WELCOME TO THE OPEN HOUSE

ENVIRONMENTAL ASSESSMENT RE-EVALUATION OVERVIEW

Roadway Typical Cross-Sections for Environmental Assessment Re-Evaluation

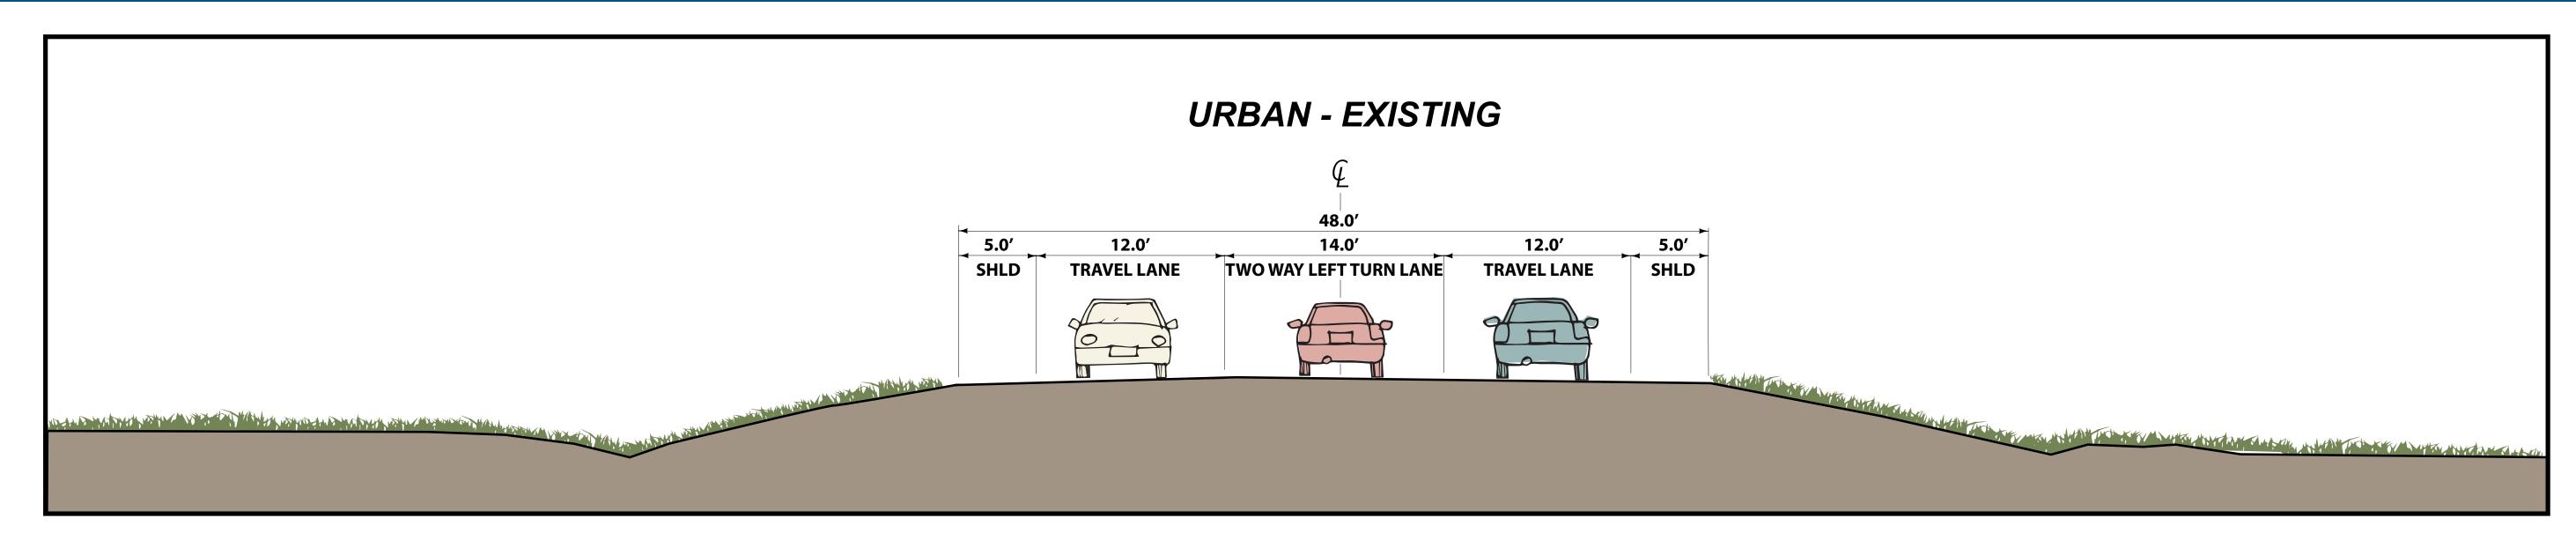
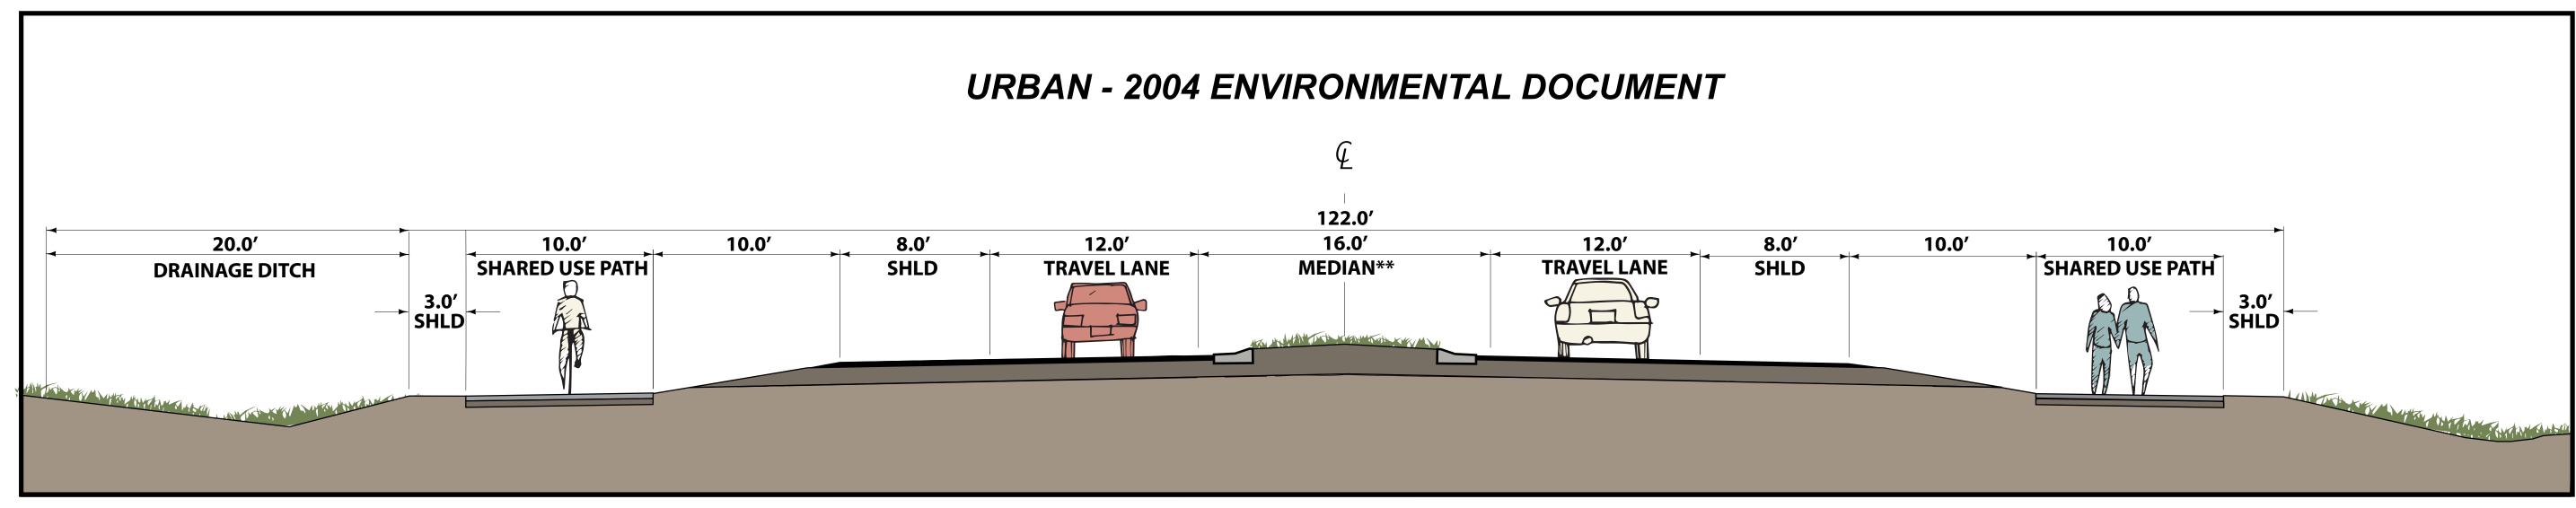
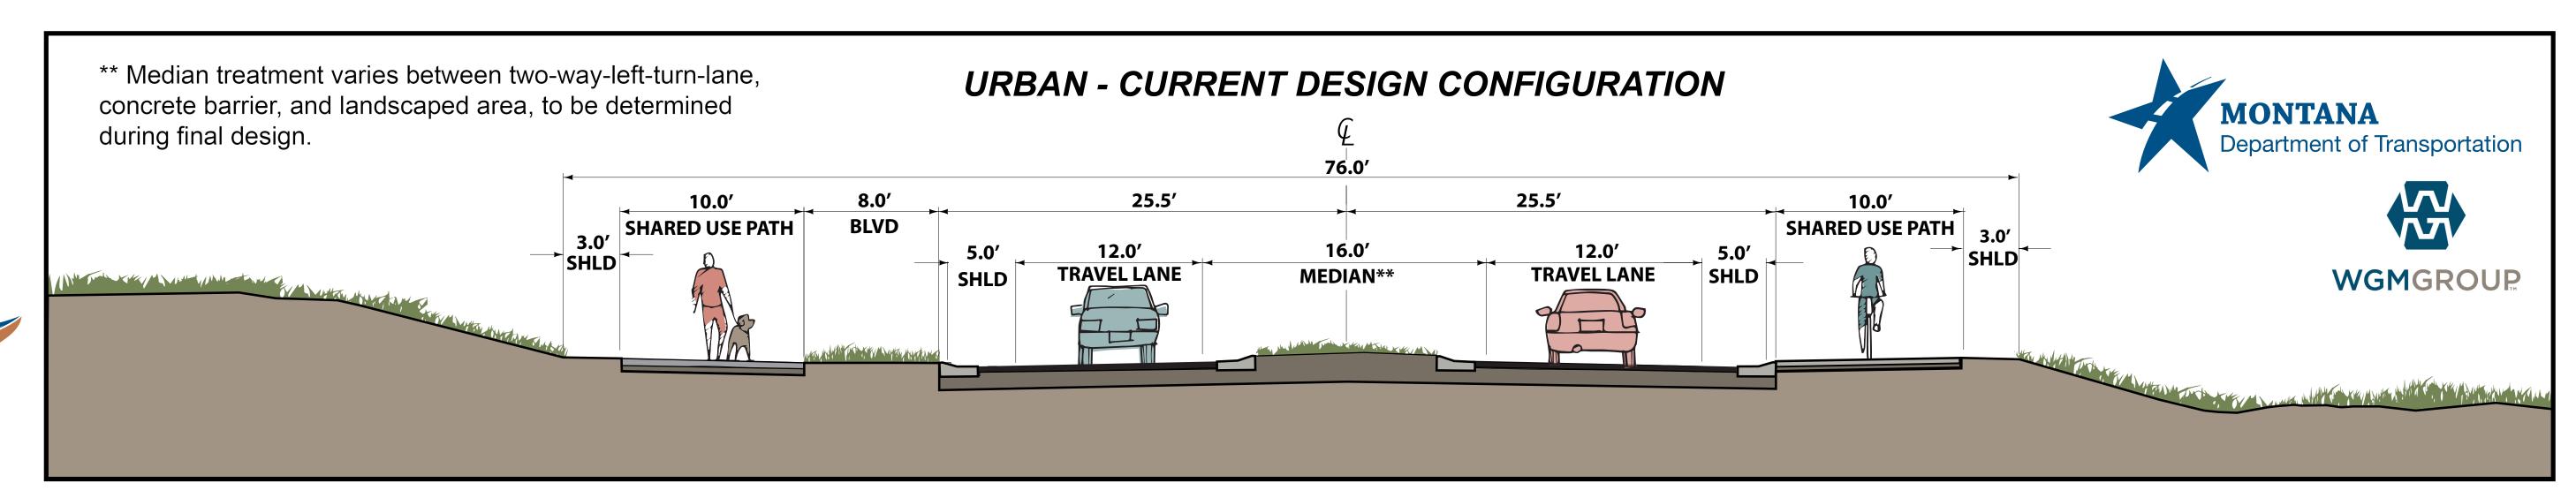
- Reducing the overall width of the improvements by eliminating roadside drainage ditches and replacing them with curb and gutter.
- Eliminating a large, proposed entry feature in the MT 35 median at the south end of the Canyon at the present site of Branding Iron Station.
- Removing from consideration right-turn lanes on MT 35.
- Extending the shared-used path on the east side of the roadway to the north end of the project. *

The accompanying graphic compares MT 35's current configuration; the roadway design originally included in the EA; and the design currently being considered in the Re-Evaluation.
